Stannah Lifts Technical Bulletin - Safety

Issue No: M8

LIFT TYPE:- STANNAH HOMELIFT

Re:- Adjustment of Stannah Homelift Concertina Panels.

Fig a. Label shown positioned on the bottom concertina panel.

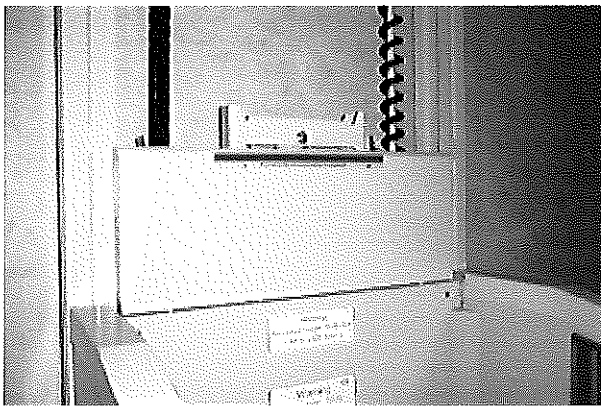
It has come to our notice that some of the Stannah Homelifts in the field have not been maintained with the correct adjustment/overlap of the rear concertina panels.

A safety label has been made available and we would recommend that this be fitted as shown to all units in the field to ensure that the overlap does not exceed the minimum dimension shown.

Should any Homelifts be found with insufficient overlap, the panels should be adjusted so that equal overlap is achieved.
